Access Compliance Report

Public Rights-of-Way

(Curb Ramps)

Intersection ID: 10038349	Main Street: SOUTH_BV	Cross Street: N/A	Location: W
ADA ID: 04692F4C7CD3	Ramp Type: Perp	Initial Pass/Fail: Fail	Overall Compliance: No
			Severity Score: 21.25

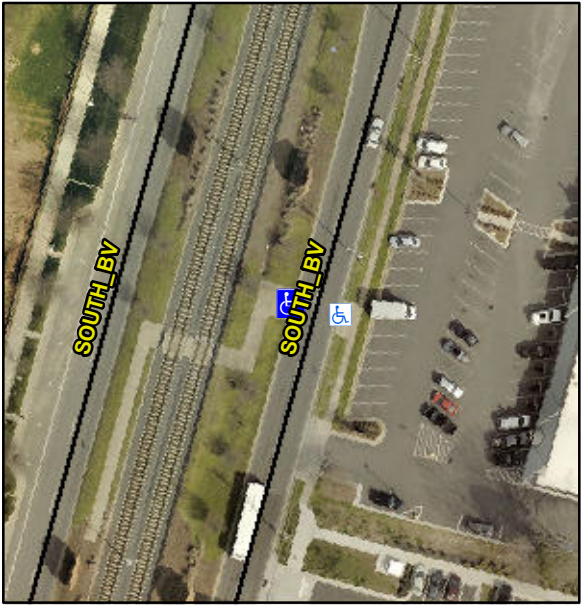
Codes/Mitigation Info/Possible Solution		Field Measurements/Component Compliance			
	Possible Solutions:				
	Remove & Replace Entire Ramp.				
	Surveyor Notes:				
	N/A				
	PROW/ADA:				
	Not Found, R304.5.1, R304.2.2				
Street 1 Name	SOUTH BV				
Stop Condition-Street 2	None				
Street 2 Name	N/A				
Stop Condition-Street 1	N/A				
Total Cost:		\$	1850.00

Compliance	Description	Data	Compliance	Description	Data
N/A	Ramp Length (in)	123.0	No	Ramp Slope (%)	10.4
No	Ramp Width (in)	47.0	Yes	Ramp XSlope (%)	1.3
N/A	Flare Type LT	N/A	N/A	Flare Type RT	N/A
N/A	Flare Slope LT (%)	N/A	N/A	Flare Slope RT (%)	N/A
N/A	Flare Traversable LT?	N/A	N/A	Flare Traversable RT?	N/A
N/A	Landing Length (in)	N/A	N/A	DWS Provided?	N/A
N/A	Landing Width (in)	N/A	N/A	DWS Contrast?	N/A
N/A	Landing Slope (%)	N/A	N/A	DWS Length (in)	N/A
N/A	Landing X Slope (%)	N/A	N/A	DWS Full Width?	N/A
N/A	Landing Curb? (Y/N)	N/A	N/A	DWS Offset (in)	N/A
N/A	Shared Landing?	N/A			
N/A	Gutter Ponding?	N/A	N/A	Gutter Slope (%)	N/A
N/A	Gutter Lip Ht (in)	N/A	N/A	Gutter X Slope (%)	N/A
N/A	Painted X Walk1?	No	N/A	Painted X Walk2?	N/A
	X Walk 1 Direction	To E		X Walk 2 Direction	N/A
N/A	X Walk 1 Width (in)	N/A	N/A	X Walk 2 Width (in)	N/A
	X Walk 1 Slope (%)	4.9		X Walk 2 Slope (%)	N/A
	X Walk 1 X Slope (%)	1.0		X Walk 2 X Slope (%)	N/A
